BCA Assessment Report

12-14 Ponsonby Parade Seaforth

Project:	12-14 Ponsonby Parade Seaforth
Reference No:	112948-BCA-r2
Date:	14 December 2020
Client:	Stephen Petesic
Client Contact:	Sean Gartner
Email:	sean@g-t.com.au
BCA Logic Contact:	Warwick Hunter
Direct:	8484 4077
Email:	whunter@bcalogic.com.au

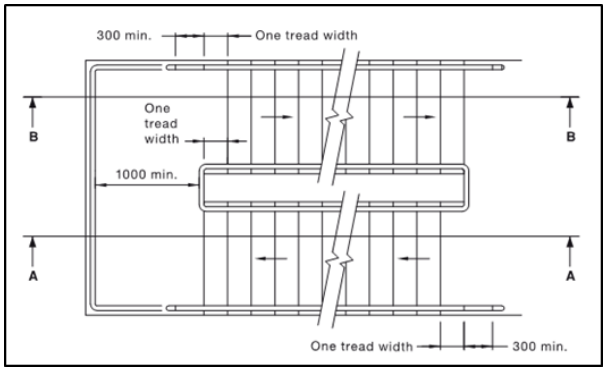
Figure 28 in AS 1428.1:2009 **Note: The handrail to the main residential non-fire isolated stairs currently extend up continually around stair flights and landings and to the top landing.** **The handrail design is not currently fully documented however, the handrail shall be kept separate to the balustrade and not transition up to the top landing. Instead that handrail shall terminate as per AS1428 with project access consultant providing advice for compliance handrail design as this is an access matter.**	
D2.18: Fixed platforms, walkways stairways and ladders	N/A	N/A
D2.19: Doorways and doors	> *Exit* doors that are power operated must be able to be opened manually under a force of not more than 110 N if there is a malfunction or failure of the power source and if leading to road or open space, open automatically if there is a power failure or on the activation of a fire or smoke alarm anywhere in the *fire compartment* served by the door. > A power operated door in a path of travel to a required *exit* must be able to be opened manually under a force of not more than 110 N if there is a malfunction of the power source.	CRA – Refer Annexure F
